ADA Compliance Program

Clark County Facilities Transition Plan Clark County Center for Community Health – 2nd Floor

Date of Survey: May 5, 2006

Item: Drinking Fountain – 2nd Floor Lobby

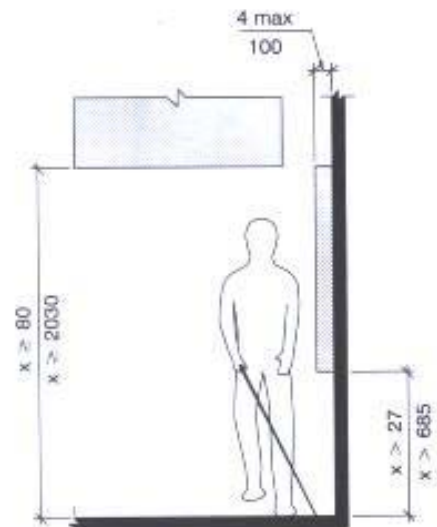
The drinking fountain shown protrudes 11 inches and the height shown is 32 3/8 inches.

- Fountains should be recessed into an alcove.
- Construct barriers around fountains

Item: Stairs – 2ndst Floor Lobby
Protrusion Limits

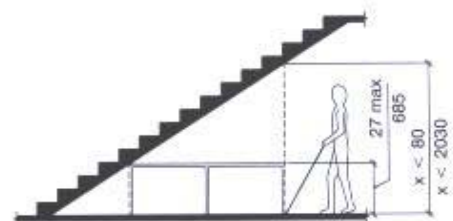
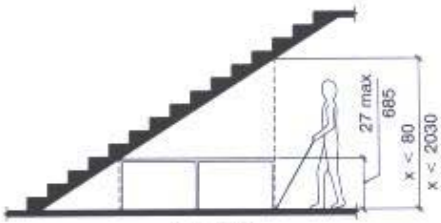
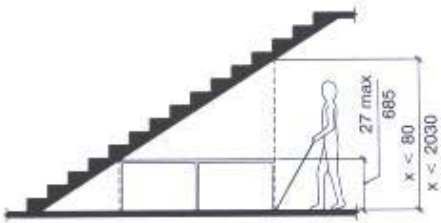
Guardrails or other barriers shall be provided where object protrusion is beyond limits allowed by Sections 307.2 and 307.3, and where the vertical clearance is less than 80 inches above the floor. The leading edge of the guardrail or barrier shall be 27 inches maximum above the floor.

- Construct Barrier
- Position furniture to block access to area under stairwell.
